Service Bulletin No. SB-AG-18 January 07,1985 Page 1 of 3

REINFORCE OF ENGINE CONTROL BELLCRANK SUPPORTS

MODELS AFFECTED: Model S2R-R1820 S/N R1820-001DC through

FIGURE 1

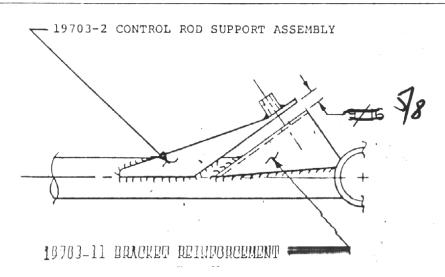
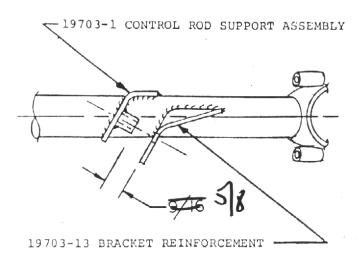
Immediately after receipt of this bulletin and within each 10 hour period of flight time until modification, inspect the 19703-1 and -2 control rod support assemblies for cracks in the bellcrank brackets. (See Figure 1). If cracks are found in the bellcrank brackets or their weld beads, immediately report this discrepancy to Ayres Corporation and complete this modification of the bellcrank brackets prior to further flight.

- 1. Remove the 19703-1 and -2 control rod support assemblies from the airplane.
- 2. Remove the paint and clean the metal surrounding the bellcrank brackets.
- 3. Weld closed any cracks found. Weld on the 19703-11 and –13 brackets reinforcements supplied with this kit. Prior to welding, clamp these brackets into position as shown on Figure 1.
- 4. Prime and paint the affected area with aircraft quality materials.
- 5. Reinstall the support assemblies and rerig the engine controls.
